# Access Compliance Report

## Public Rights-of-Way

### (Curb Ramps)

Intersection ID: N/A	Main Street: NORTHLAKE_PLAZA_DR	Cross Street: N/A	Location: NW
ADA ID: 11BB0DF8AECD	Ramp Type: PerpDiag	Initial Pass/Fail: Pass	Overall Compliance: No
Codes/Mitigation Info/Possible Solution		Field Measurements/Component Compliance	
Severity Score: 7.5

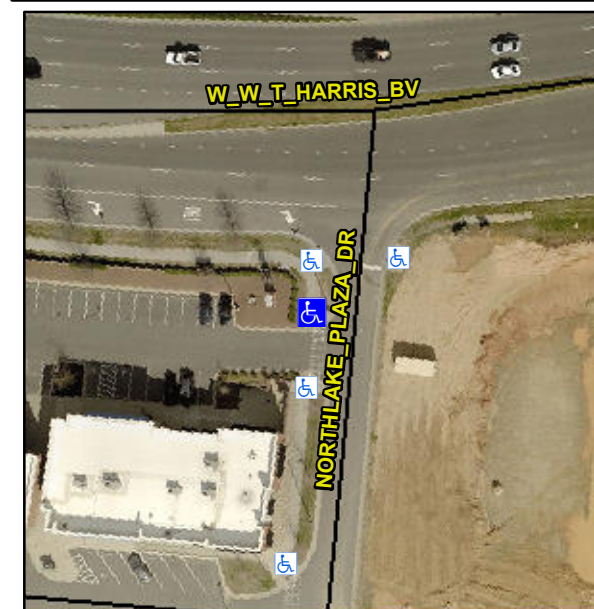
**Not Found, R304.2.2-Perp, R304.3.2-Para, R302.7.2, R304.5.3**

Compliance	Description	Data	Compliance	Description	Data
N/A	Ramp Length (in)	117.0	Yes	Ramp Slope (%)	8.0
Yes	Ramp Width (in)	48.0	Yes	Ramp XSlope (%)	0.5
N/A	Flare Type LT	Sloped	N/A	Flare Type RT	N/A
N/A	Flare Slope LT (%)	2.5	N/A	Flare Slope RT (%)	11.1
N/A	Flare Traversable LT?	No	N/A	Flare Traversable RT?	No
Yes	Landing Length (in)	61.5	Yes	DWS Provided?	Yes
Yes	Landing Width (in)	71.0	Yes	DWS Contrast?	Yes
No	Landing Slope (%)	5.6	Yes	DWS Length (in)	24.0
Yes	Landing X Slope (%)	2.3	Yes	DWS Full Width?	Yes
N/A	Landing Curb? (Y/N)	No	Yes	DWS Offset (in)	2.0
N/A	Shared Landing?	No			
Yes	Gutter Ponding?	No	Yes	Gutter Slope (%)	3.7
No	Gutter Lip Ht (in)	0.5	No	Gutter X Slope (%)	5.0
N/A	Painted X Walk1?	Yes	N/A	Painted X Walk2?	No
	X Walk 1 Direction	To S		X Walk 2 Direction	To E
N/A	X Walk 1 Width (in)	56.0	N/A	X Walk 2 Width (in)	N/A
	X Walk 1 Slope (%)	0.8		X Walk 2 Slope (%)	2.1
	X Walk 1 X Slope (%)	2.1		X Walk 2 X Slope (%)	4.4

**Remove & Replace Curb Ramp With Two New Directional Ramps or Equivalent. Remove & Replace Gutter.**
